DART AEROSPACE LTD	Work Order: 97872
Description: Crosstube Assembly	Part Number: D407-667-145
Inspection Dwg: D407-667-145 Rev: C	Page 1 of 2

DESIGN	DP	DART AEROSPACE LTD	
DRAWN	RF	HAWKESBURY, ONTARIO, CANADA	
CHECKED	JP	DRAWING NO.	REV. C
MFG. APPR.	JP	D407-667-145	SHEET 3 OF 4
APPROVED	JP	TITLE	SCALE
DE APPR.	JP	CROSSTUBE ASS'Y (407 HIGH FWD)	NTS
DATE	08.11.06	COPYRIGHT © 2002 BY DART AEROSPACE LTD THIS DOCUMENT IS PRIVATE AND CONFIDENTIAL AND IS SUPPLIED ON THE EXPRESS CONDITION THAT IT IS NOT TO BE USED FOR ANY PURPOSE OR COMMUNICATED TO ANY OTHER PERSON WITHOUT WRITTEN PERMISSION FROM DART AEROSPACE LTD.

DRAWING NO. D407-667-145	TITLE CROSSTUBE ASS'Y (407 HIGH FWD)	REV. C	DART AEROSPACE LTD ENGINEERING ORDER		D.E.O. NO. D407-667-145-C-1	SHEET NO. SHEET 1 OF 1	SCALE NTS
DRAWN 97	CHECKED ASS	MFG. APPR. IB	APPROVED WD		DE APPR. H		
DATE 11.07.15	DATE 11.07.22	DATE 11.07.22	DATE 11/07/22		DATE 11.07.21

DRAWING NO. D407-667-145	TITLE CROSSTUBE ASS'Y (407 HIGH FWD)	REV. C	DART AEROSPACE LTD ENGINEERING ORDER		D.E.O. NO. D407-667-145-C-2	SHEET NO. SHEET 1 OF 1	SCALE NTS
DRAWN AJS	CHECKED	MFG. APPR.	APPROVED		DE APPR.		
DATE 12.08.02	DATE 12.08.02	DATE 12.08.02	DATE 12.08.02		DATE

DETAIL P
BONDING STRAP INSTALLATION 2 PL

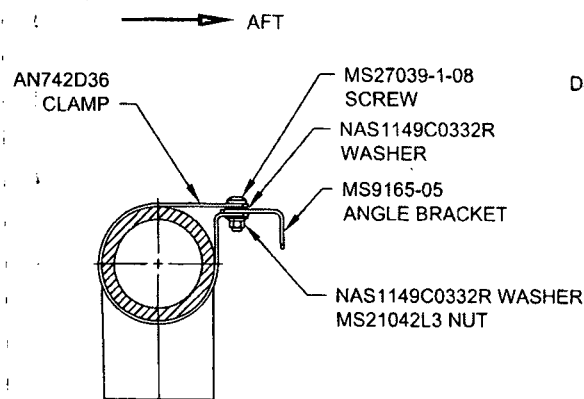
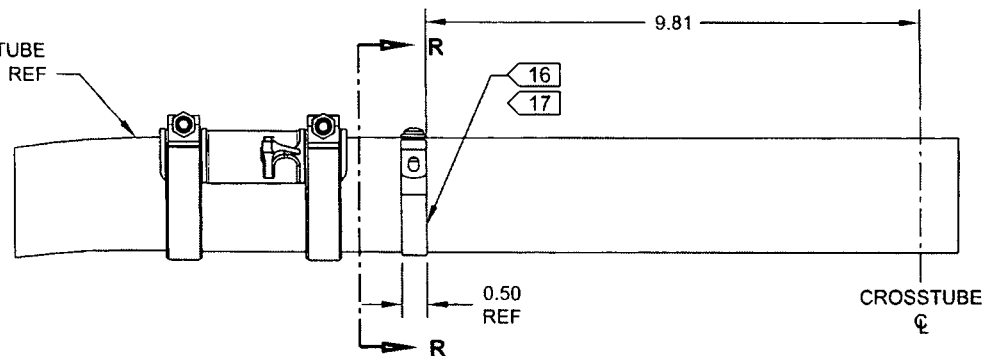
ADD ELECTRICAL GROUNDING STRAP

ITEM	QTY -145	PART NUMBER	DESCRIPTION
1	X	D407-667-145	CROSSTUBE ASSEMBLY (407 HIGH FWD)
⚡			
10	2	AN742D36	CLAMP
11	2	MS9165-05	ANGLE BRACKET
12	2	MS21042L3	NUT (OR MS21042-3)
13	2	MS27039-1-08	SCREW
14	4	NAS1149C0332R	WASHER (OR AN960C10L)

- 16) MASK AREA UNDER CLAMP PRIOR TO PAINTING
- 17) SEAL EDGES WHERE AN742D36 CLAMP MEETS WITH THE CROSSTUBE USING SIKAFLEX-241/-291 OR MIL-S-8802 CLASS B2 OR PROSEAL 890 SEALANT
- 18) PERFORM RESISTANCE CHECK TO ENSURE MAX RESISTANCE IS 10 MILLIOHMS
